BUILDINGS ORDINANCE (CAP. 123)
Order by the Building Authority under section 24(1)

Order No.:	C/TB/005900/20/HK	Office of the Building Authority
BD Ref. :	EB/2193/54/N01S	Buildings Department Headquarters,
To :	ALL OWNERS OF	North Tower, West Kowloon
	NOS. 5-7 PAK SHA ROAD HONG KONG	Government Offices, 11 Hoi Ting Road, Yau Ma Tei, Kowloon.

Plan annexed to Order No. / 此圖則附於連命令編號 : C/TB/005900/20/HK
 BD File Ref. / 檔案編號 : EB/2193/54/N01S
 Premises / 處所 : NOS. 5-7 PAK SHA ROAD, HONG KONG
 (中文地址只供參考: 香港白沙道 5-7 號)

G/F Plan
地下平面圖

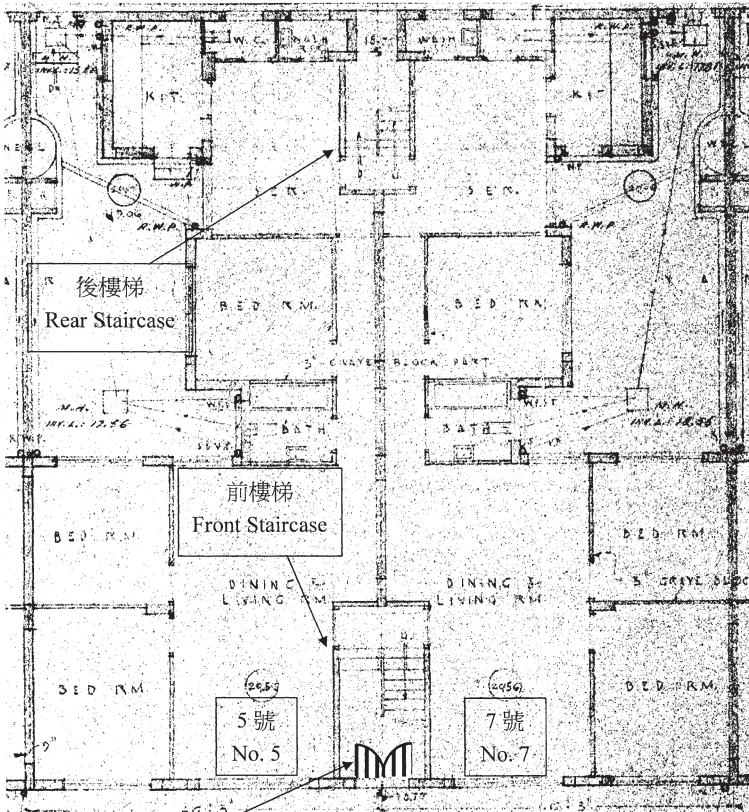
- (i) An inward swinging metal gate installed at the exit of the front staircase on G/F leading to Pak Sha Road.

- (a) As a result of the building works at item (i) above, Regulation 41(1) of the Building (Planning) Regulations, which requires the building to be provided with such means of escape in case of emergency as required by the intended use of the building, has been contravened.

- (a) Demolish the said building works described under item (i) above; and
(b) Reinstatement of the parts of the building so affected by the building works under item (i) above in accordance with the plans approved by the Building Authority.
